ADDENDUM NO. 2

JOHN STREET PARK SITE IMPROVEMENTS 2025 - CONSTRUCTION PHASE

BID #25-037

ISSUED: October 17, 2025

Temporary Project Sign

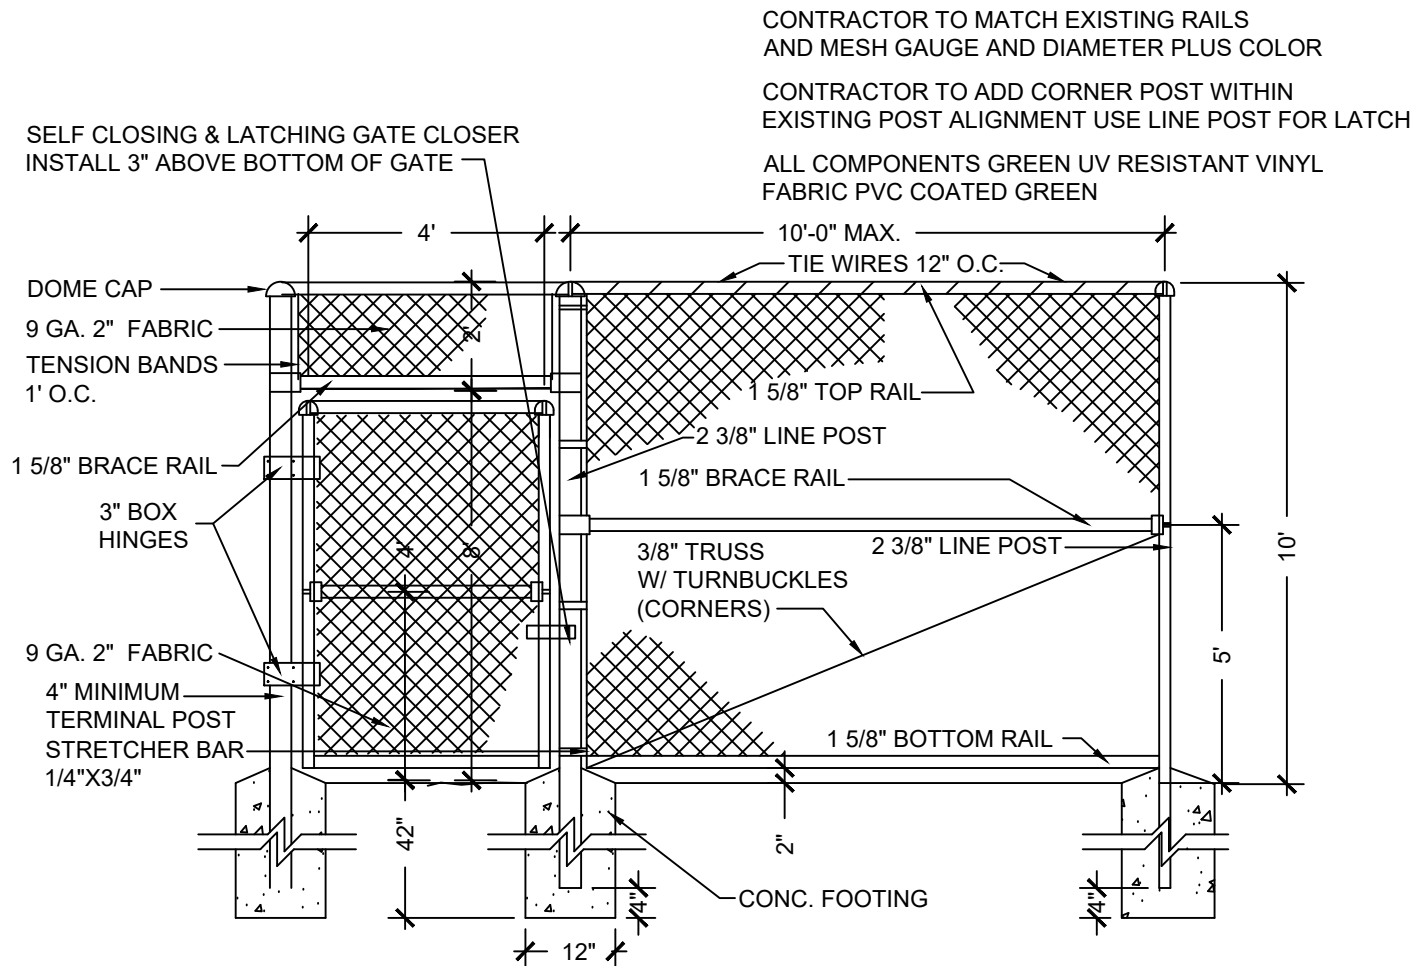
- Updates to sheets: L-2 to address parking lot layout
- UPDATES TO ELECTRICAL PLAN-See notes a-d below for additional scope of work. Please note the revised plans are attached to addendum.
 - a) A new step-down transformer to drop the voltage from 480 volts to 208 volts. (The rating for the step-down transformer will be shown on the drawings).
 - b) There is another electrical cabinet that will house a new panel called "NP2" to provide circuiting for the receptacles around the site.
 - c) There is another utility meter being added onto the other electrical cabinet to measure the amount of electricity used by panel "NP2"
 - d) These changes are made next to the current electrical cabinet on the site plan.
- Detail Added for proposed gate at basketball court park side entrance
- Detail Added for temporary project signs (qty 2)

Quantity = 2

Installed on chain link fence remaining at the basketball courts

Material = Vinyl with 6 metal grommets for attachment

Size: 4' x 8'
